UNITED STATES PATENT AND TRADEMARK OFFICE

APPLICATION NO.	FILING DATE	FIRST NAMED INVENTOR	ATTORNEY DOCKET NO.	CONFIRMATION NO.
10/824,559	04/14/2004	Karsten Kohler	TD 149	6248
27956	7590	08/04/2005	EXAMINER ROYAL, PAUL	
KLAUS J. BACH 4407 TWIN OAKS DRIVE MURRYSVILLE, PA 15668			ART UNIT 3611	PAPER NUMBER

Office Action Summary

DETAILED ACTION

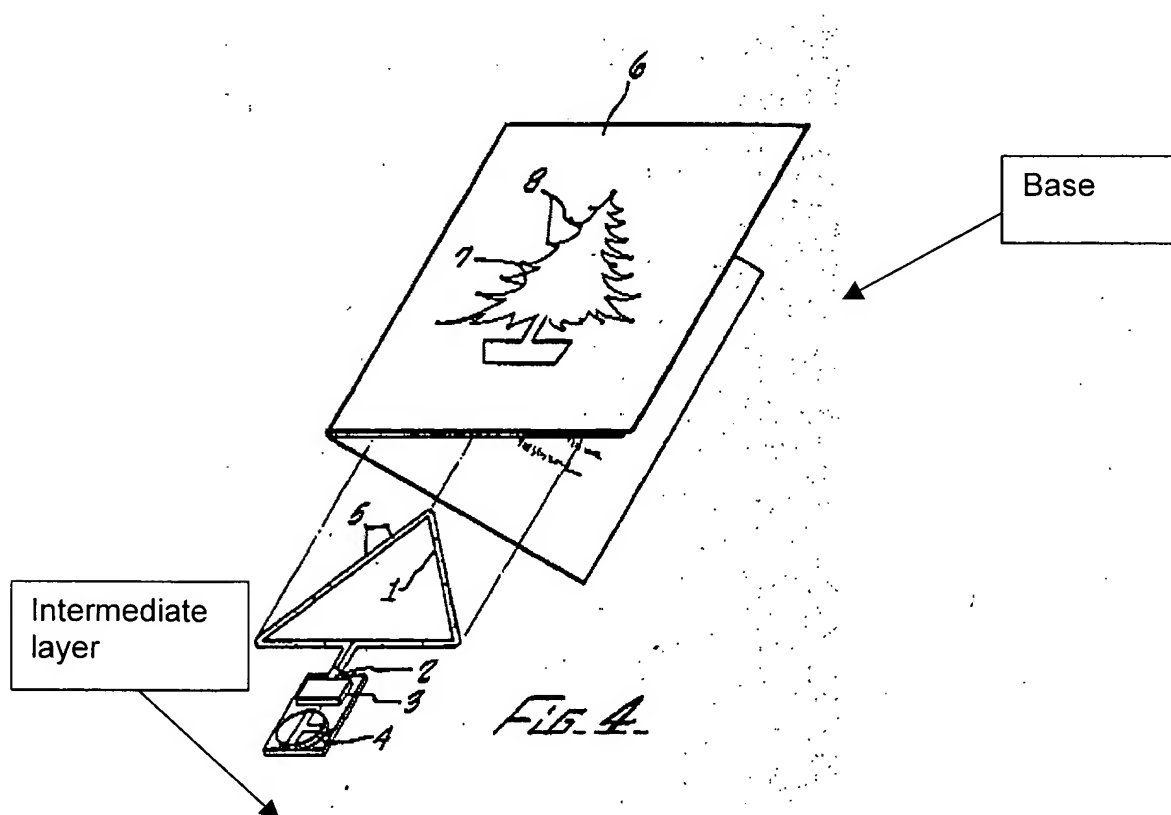
Ku teaches a greeting card with a blinking light apparatus comprising:

a base (Base, see Examiner's annotated Figure 6);

at least one light emitting element (2) disposed on said base (Base);

a cover layer (6);

a power supply (4); and

an operating element/control unit (3).

Note, the power supply, operating element, and light emitter are integrated circuits and appropriate mechanisms such as a battery and a switch, which are shown mounted on an intermediate layer, see Examiner's annotated Figure 4.
